# AGENDA

2. 22-0014 Halifax Self Storage

CITY OF COLUMBIA TENNESSEE  
 ARCHITECTURAL DESIGN REVIEW  
 STAFF REPORT

**ART 22-0014**

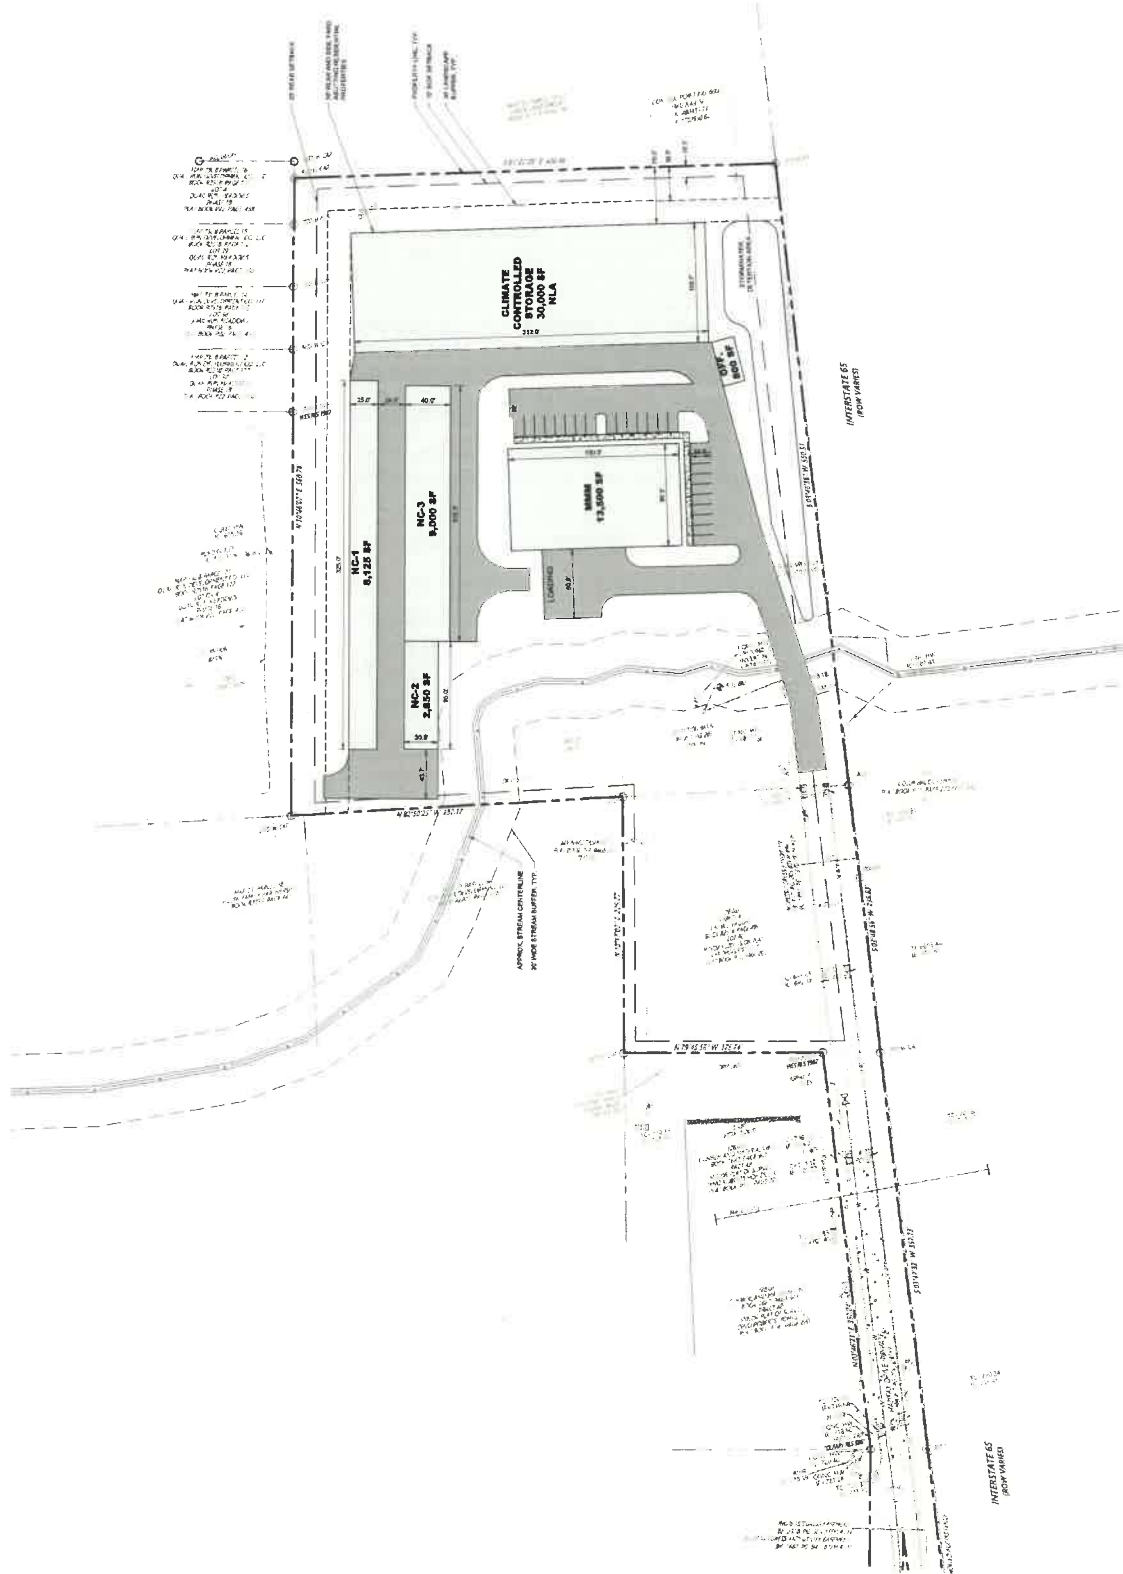
This request includes five storage buildings with all buildings having a façade material of fiber cement board (*Hardie Plank*). Please refer to attached site plan for reference.

- Building NLA will comprise of a 105 X 312 indoor self-storage structure with a maximum gable height of 20'. The façade material for the structure will consist of fiber cement board siding accented by fiber cement clad pilasters every 32'. This proposal would meet the guidelines as described for material and articulation.

- Building MMM will consist of a 90 X 150 structure with a maximum height of 19'6" at the gable. The façade material on the structure will consist of fiber cement board siding accented by fiber cement clad pilasters every 35' on the north and south elevation, with fiber cement clad pilasters every 27' on the east and west elevation. This proposal would meet the guidelines as described for material and articulation.

- Building NC-1 will comprise of a 25 X 325 structure that will serve as self-storage units with exterior access by roll-up doors. The façade material of the structure will consist of fiber cement board siding accented by fiber cement clad pilasters every 28'4" on the east and west elevations, with fiber cement clad pilasters every 28' on the east and west elevation. This proposal would meet the guidelines as described for material and articulation.

- Building NC 2-3 will be a 40 X 225 structure with an additional inset of a 95 X 30 self-storage structure. The façade material of the structure will consist of fiber cement board siding accented by fiber cement clad pilasters every 28'4" on the east and west elevations, with pilasters every 28' on the east and west elevation. This proposal would meet the guidelines as described for material and articulation.

- A 20 X 40 office building will be located on the site with a primary façade material of fiber cement board siding. This proposal would meet the guidelines as described for material. The façade has two window inserts.
